Addendum No.1
MILLER CREEK BANK STABILIZATION (2016) – REACH #590C
Bid # 2016-0372
City Project # 1356
Bid Opening: 2:00pm June 1, 2016

EXHIBIT A
Addendum No. 1

OVERVIEW
MILLER CREEK
BANK STABILIZATION
CITY OF DULUTH PROJECT NO. 1356
ST 1

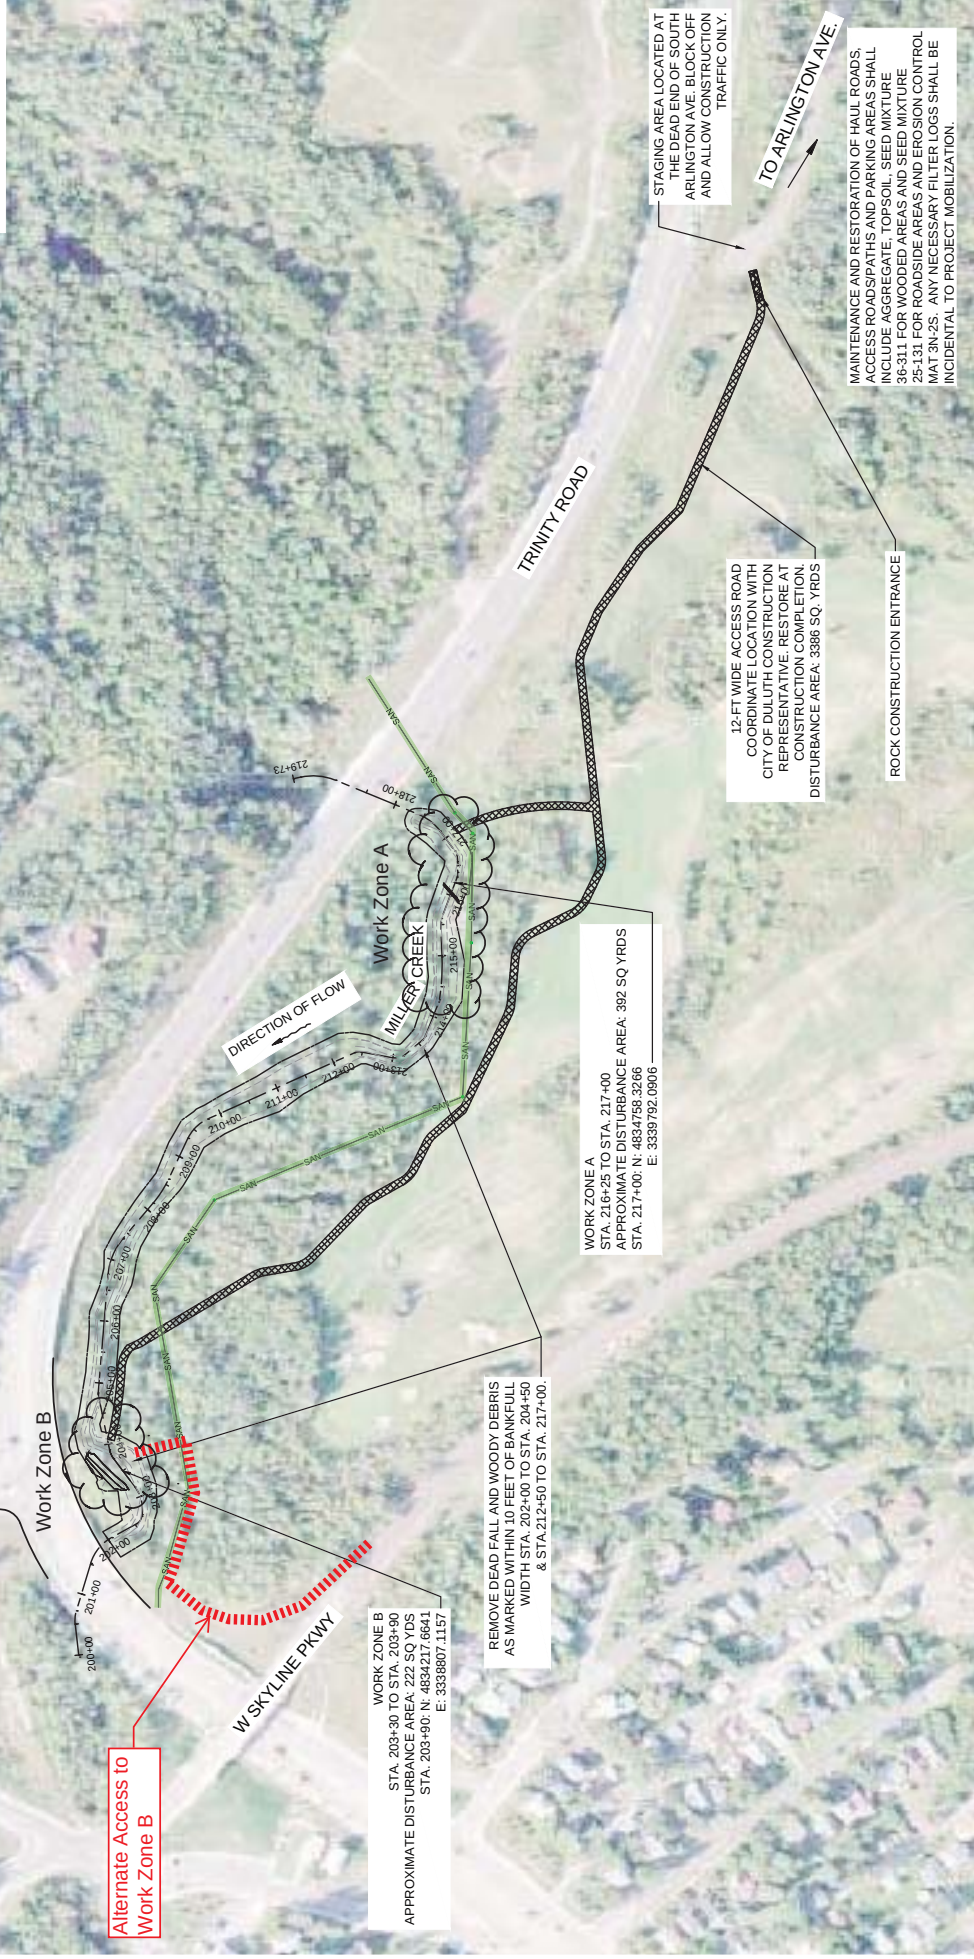
- B. The seed mixtures designated for restoration of access road/paths shown in the notes on Plan **sheet ST-1** shall supersede the seed mixes described in the technical and special provisions for turf restoration of any access road/path.
- C. An alternative access road/path to Work Zone B may be considered by the Engineer. Refer to the attached **Addendum Exhibit A** depicting a potential modification to the sheet ST-1 of the Plans.

The Engineer may consider the use of alternate access routes upon receipt of written request by the Contractor. Request shall include the description of access route, permits, temporary facilities, and restoration plan.

Access to Work Zone B from Skyline Parkway along MN/DOT right of way will be considered if the Contractor secures permit from DOT, permissions from WLSSD, and provides temporary traffic safety measures meeting the Engineer's approval at the bridge on Skyline Parkway.

Access routes plans shall be submitted to Engineer not less than 14 days prior to use.

Irrigation and drainage system pipes that may be located near potential access paths will be located by the golf course prior to starting work. The Contractor shall provide protective measures (i.e. timber pads, temporary fill, or other methods approved by the Engineer) to transfer equipment loads over/away from the existing irrigation and drainage pipes to minimize the potential for damage. Where, in the opinion of the Engineer, the Contractor makes a reasonable effort to avoid damaging the pipes, any necessary repairs will be treated as Extra Work.
